MONTEREY PENINSULA WATER MANAGEMENT DISTRICT

**ADDENDUM NO. 2
TO
CONTRACT DOCUMENTS**

**For Construction
Of
BACKFLUSH BASIN EXPANSION PROJECT**

This Addendum (including attachments), dated September 6, 2018, includes 27 pages.

DEMOLITION & FENCING PLAN
MONTEREY PENINSULA WATER MANAGEMENT DISTRICT
SANTA MARGARITA ASR FACILITY SITE EXPANSION
1910 GENERAL JIM MOORE BOULEVARD

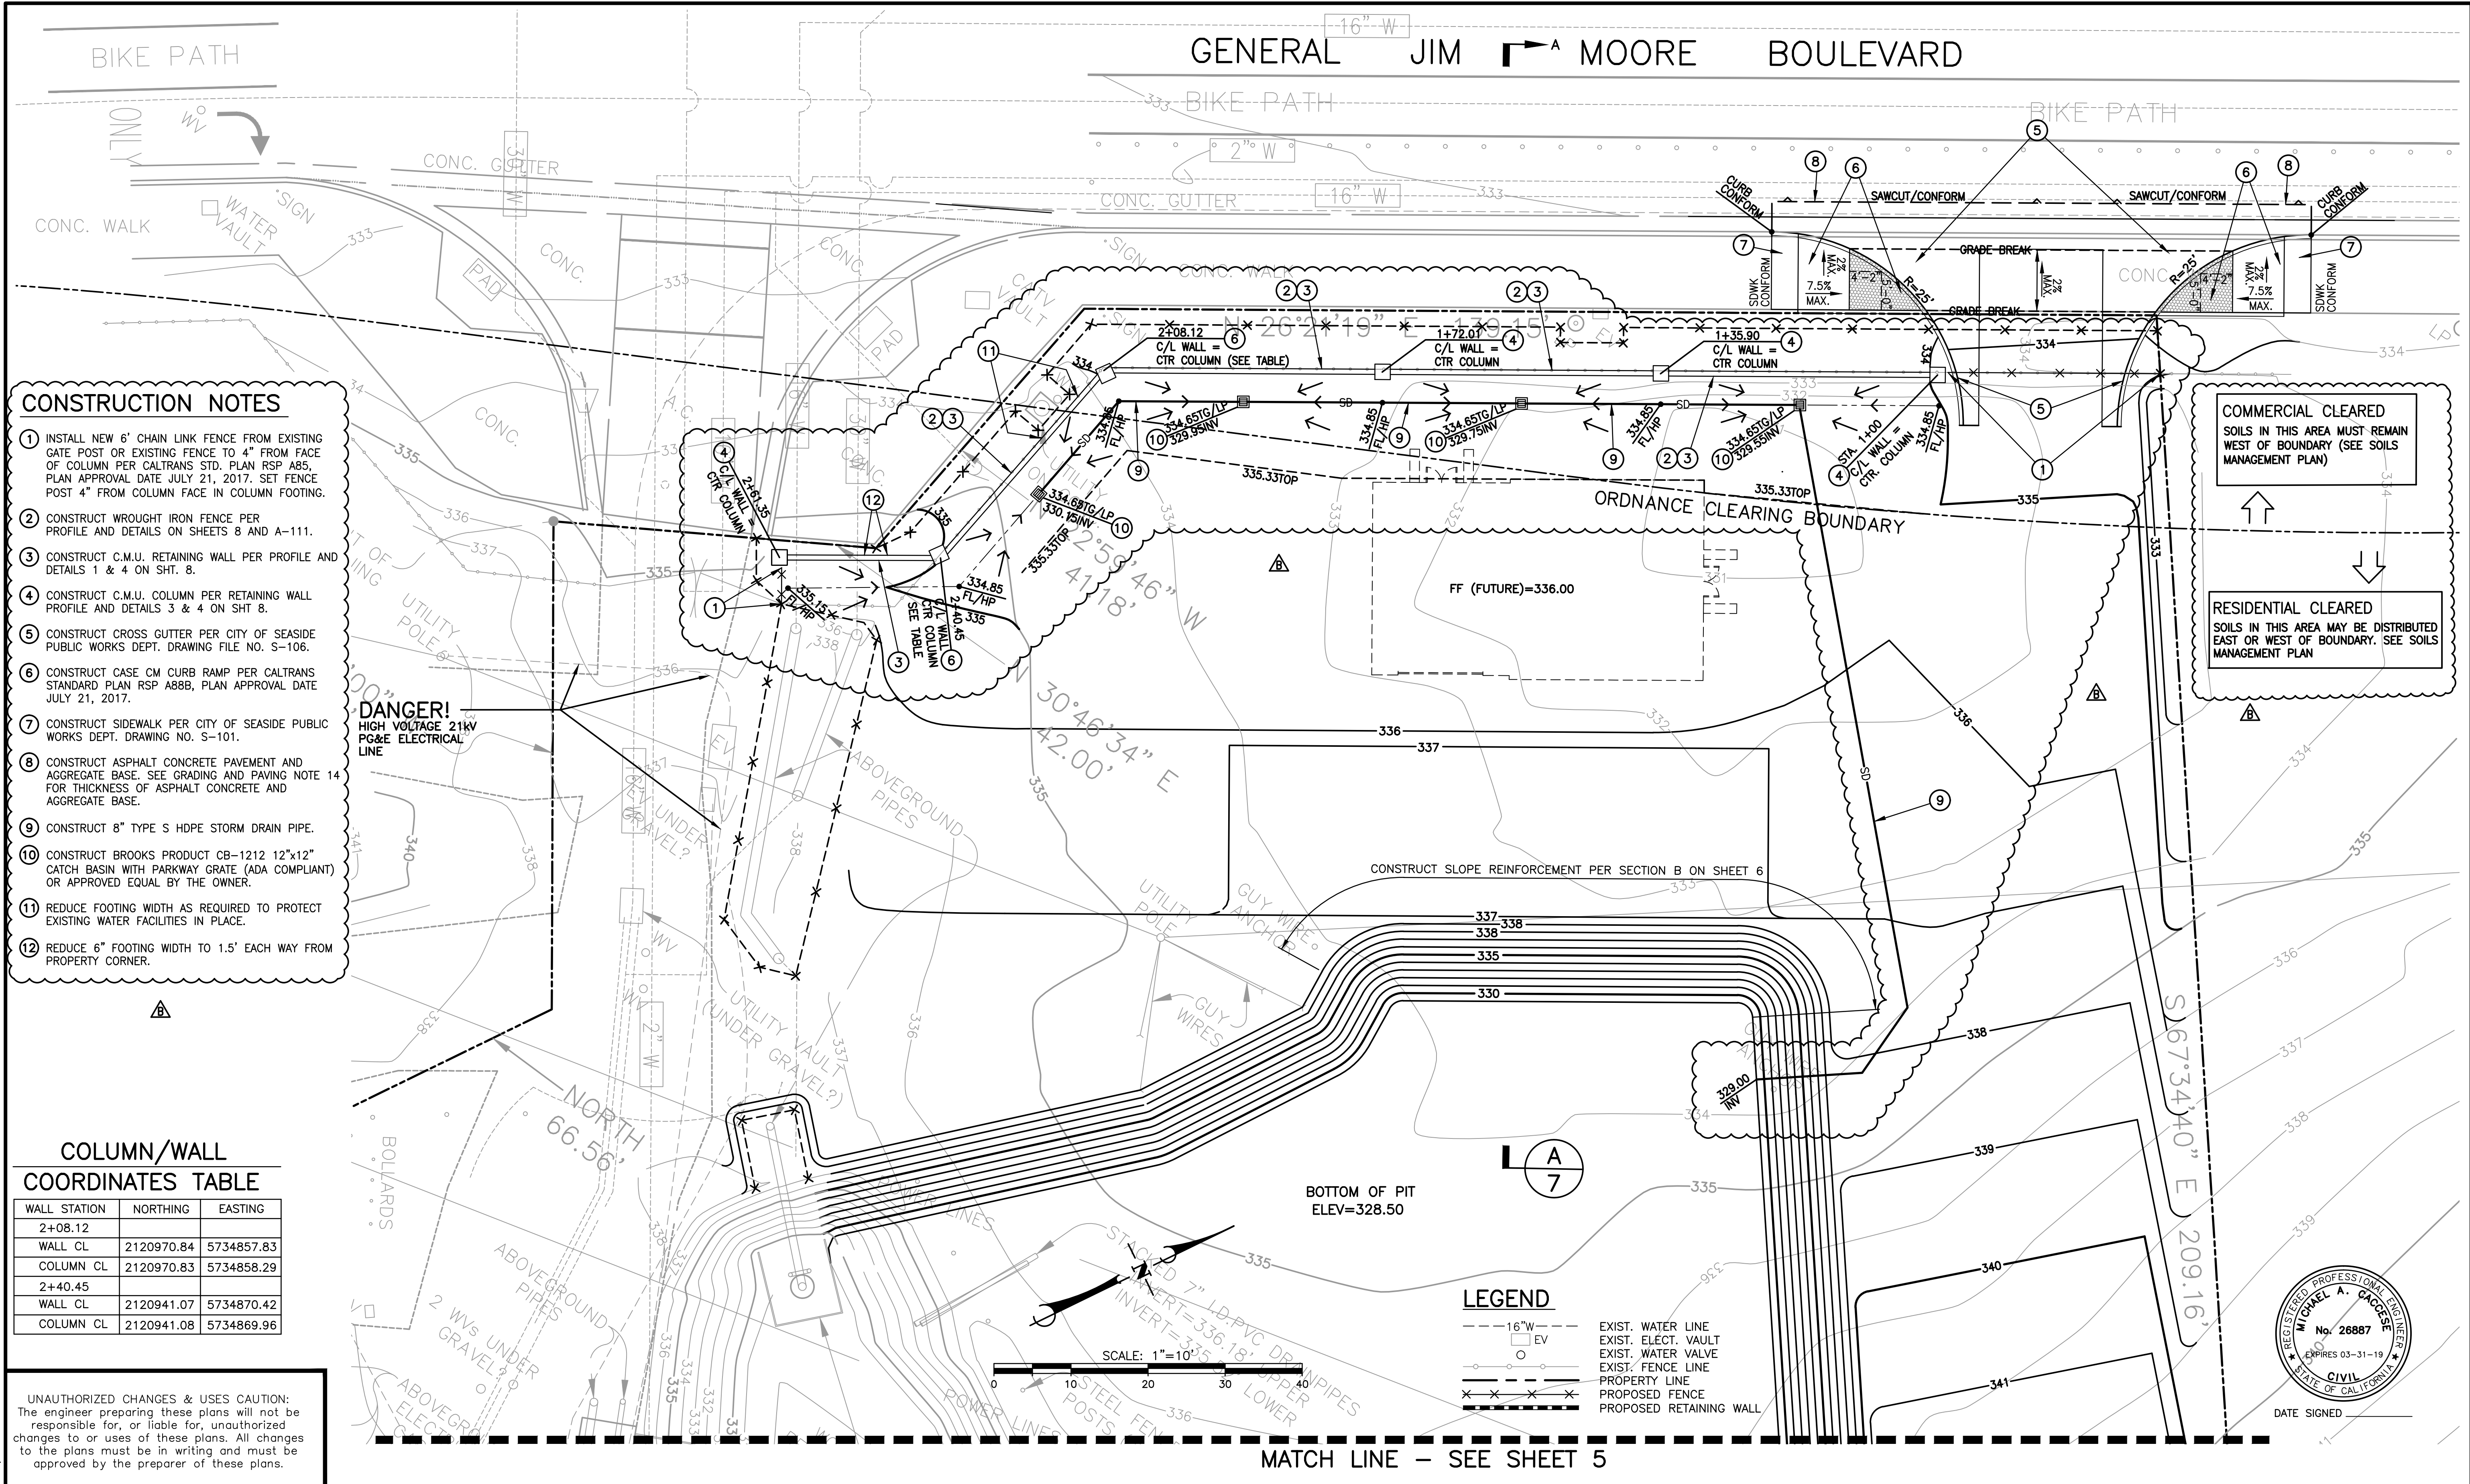
Which of the bid items on the Bid Form covers the Remove and Salvage the existing fence, the Relocated Location of the Salvaged Fence shown on sheet 3 as well as the New chain link fence shown on sheet 4.

It is the Bidders decision to distribute bid items in the bid form. We have provided Bid Item 6, "Completion of all other work specified in the Contract Documents complete and in place, including demobilization, site cleanup, and site restoration".
